TO:		COUNCIL ASSESSMENT PANEL
DATE:		28 JANUARY 2021
SUBJECT:		COUNCIL ASSESSMENT REPORT
AUTHOR:		ALEXANDER STAMATOPOULOS
		DEVELOPMENT OFFICER PLANNING
ATTACHMENTS:		1. LOCALITY PLAN
		2. PROPOSED PLANS
DA NO.	:	110/00880/20
APPLICANT	:	HEATHER AND MICHAEL KILMARTIN
LOCATION	:	3 DUNLUCE AVENUE, BRIGHTON
DEVELOPMENT PLAN	:	HOLDFAST BAY COUNCIL CONSOLIDATED - 2 JUNE 2016
ZONE AND POLICY AREA	:	RESIDENTIAL CHARACTER ZONE POLICY AREA 13 (BRIGHTON AND
		GLENELG EAST)
NATURE OF DEVELOPMENT:		MERIT
PROPOSAL	:	CARPORT LOCATED FORWARD OF ASSOCIATED DETACHED DWELLING
EXISTING USE	:	RESIDENTIAL
REFERRALS	:	NIL
CATECODY

Figure 1: Existing streetscape view of the subject site

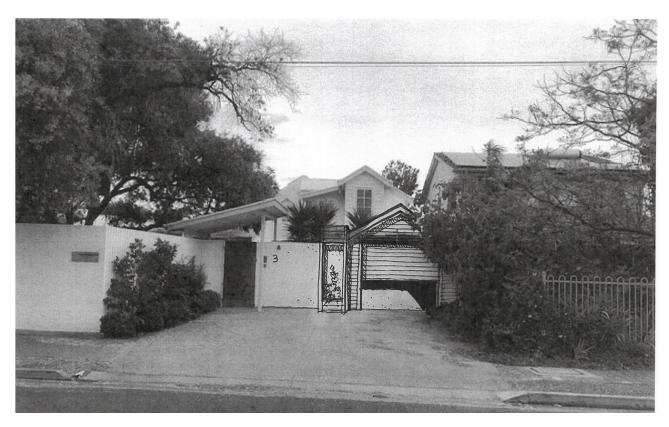
Currently, the subject lands front façade contains a solid front fence that masks the dwelling façade and the front yard. When comparing the existing built form to the Figure 2 superimposing the carport, there will be little change in the subject sites appearance to the streetscape. The inclusion of the carport will introduce an entry door, a feature planter structure, a roller door and a pitched roof which will address Dunluce Avenue. These elements are not considered to dominate the dwelling façade given the subject site's circumstances but rather provide visual interest to what is a bland solid wall.
